World Forum for Harmonization of Vehicle Regulations**Working Party on Passive Safety****Fifty-fifth session**

Regulation No. 11 (Door latches and hinges)**Proposal for the 04 series of amendments****Submitted by the expert from Germany***

Arrangements of approval marks

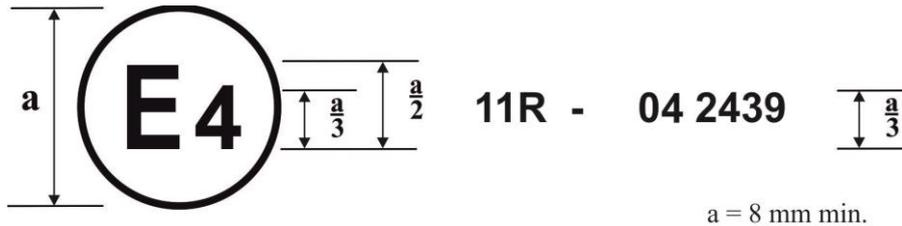
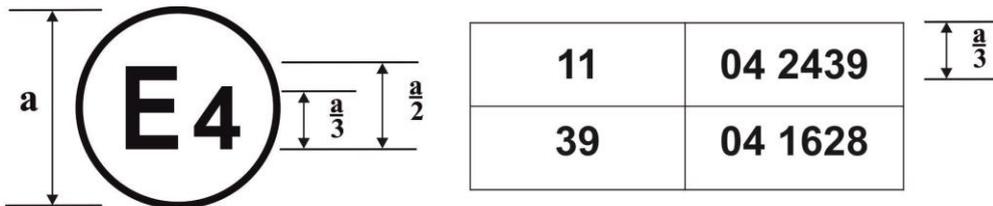
Annex 2, amend to read:

Model B

The above approval mark ... Regulation No. 11 as amended by the 04 series of amendments ..."
